STERLING RANCH ROAD & BRIARGATE PARKWAY STORM PLANS

COUNTY OF EL PASO, STATE OF COLORADO
STORM SEWER PLANS
MARCH 2022

CD-Storm_V2.pdf Markup Summary

JOB NO. 25188.03

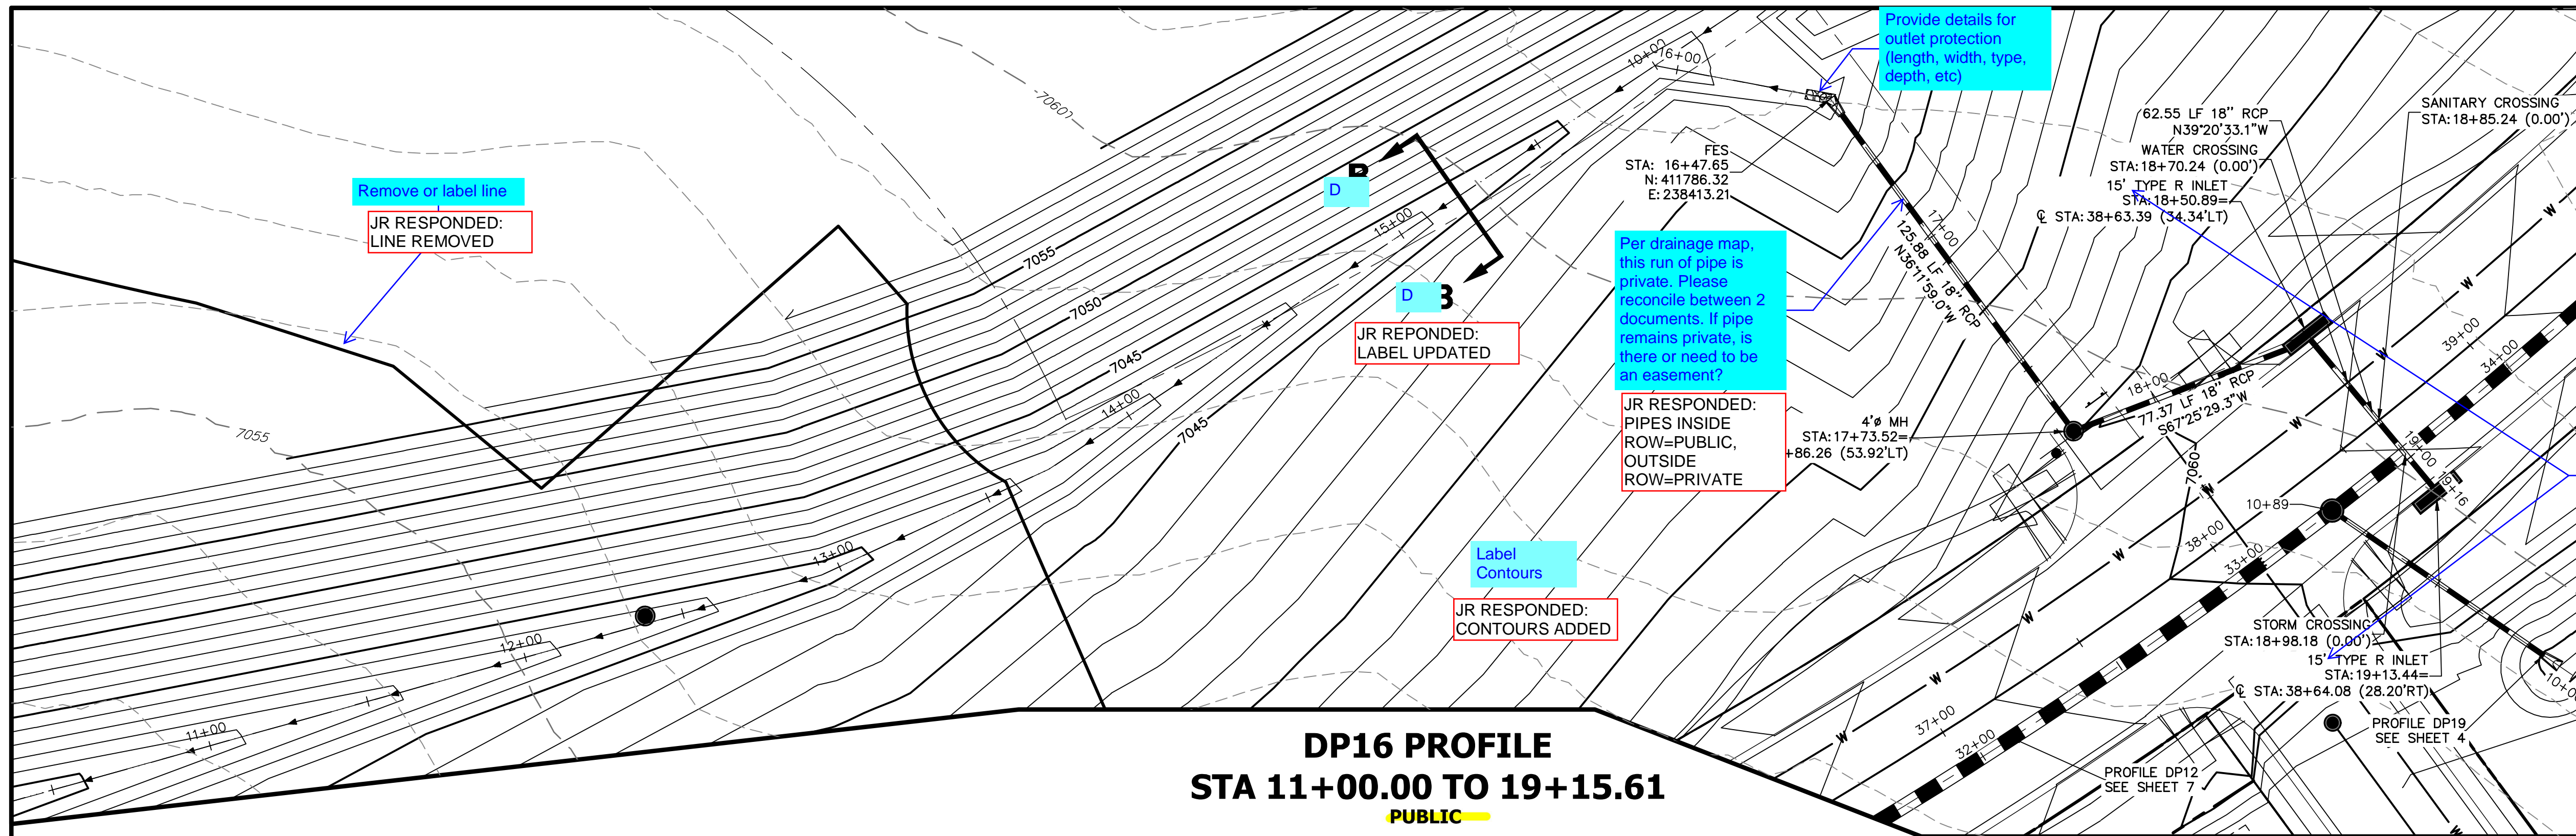
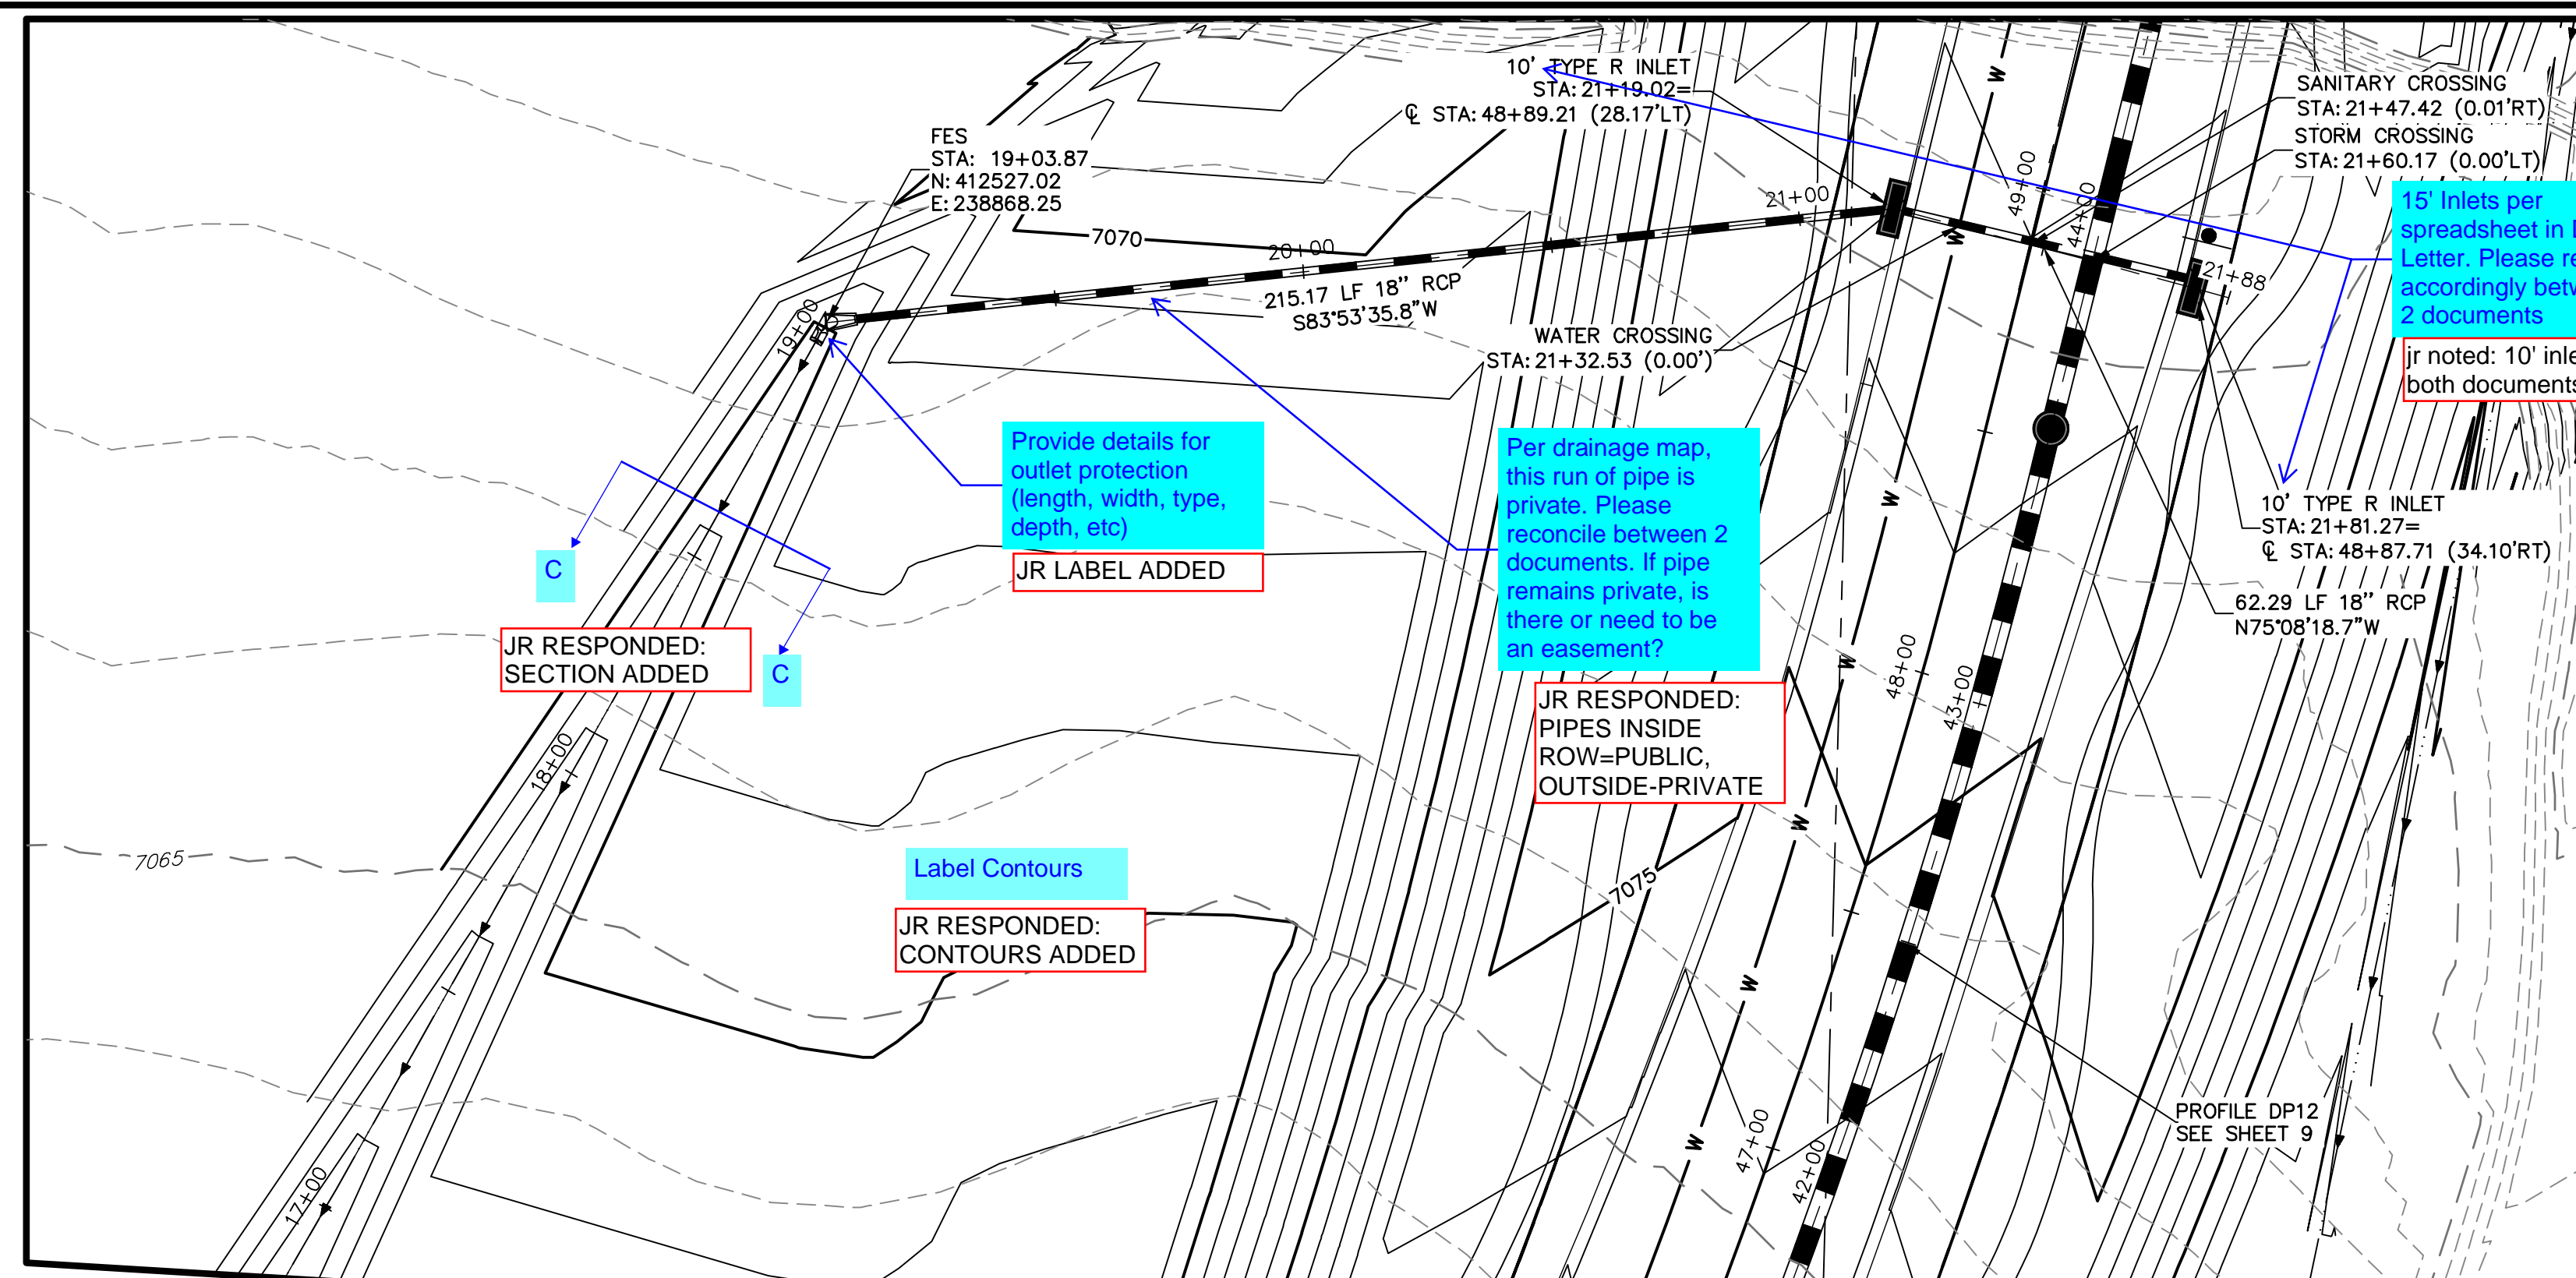
Include detail for Swale C-C section

JR RESPONDED:
SECTION ADDED
TO SHEET

WQCV/EURV ORIFICE
PLATE DETAIL
SCALE: 3/8\"/>

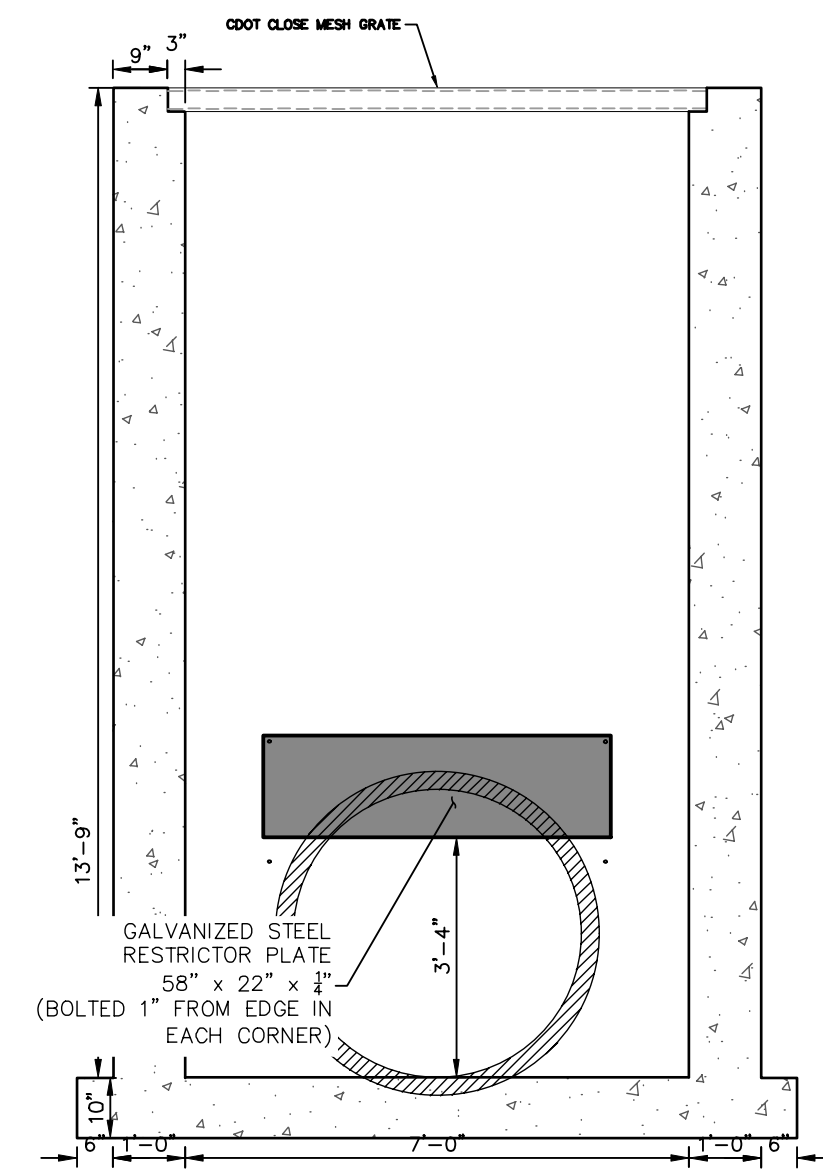
Per pond spreadsheet, orifice plate
has 4 stages. Please revise
accordingly between 2 documents

JR Response: orifice
plate updated
